**AEROPLANE AND ARMAMENT
EXPERIMENTAL ESTABLISHMENT**

METEOR MK.8 WF.716
(SERIAL 8)

RADIO ACCEPTANCE TRIALS

FIG. 1.

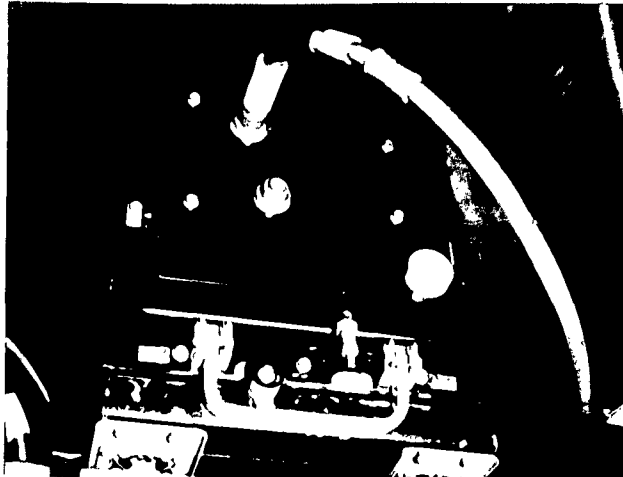
3.1.2 The transmitter aerial co-axial feeder was considered too long, and liable to be damaged by personnel working in the radio bay. (Fig. 1) The use of a 90° entry plug fitted to the feeder, would enable the cable to be laid over the top of the transmitter unit, thus reducing the feeder length.

4.1 The transmitter co-axial feeder should be re-routed over the top of the transmitter receiver, thus reducing the length of co-axial feeder, and a 90° entry plug substituted for the straight entry plug fitted.

FIG. 3.

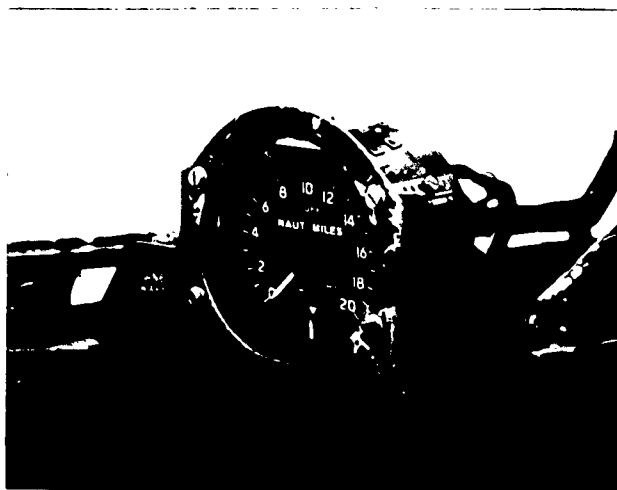
3.1.7 The Range and Heading Indicator was mounted on a resilient mounting on the port side of the cockpit, angled towards the pilot. (Fig. 3.) This position was satisfactory for observation, but greater ease of observation would be achieved if the indicator was moved back as far as possible in its present attitude. The use of the 90° entry socket on the connector from the Junction Box to the indicator would facilitate this alteration of indicator position, and would also be better for servicing.

3.4.3 During night flying the Range and Heading Indicator was difficult to read, as it was out of the area of instrument lighting.

4.2 The straight entry plug on the junction box-indicator connector should be replaced by a 90° plug. This would facilitate servicing, and enable the indicator to be set closer to the instrument panel.
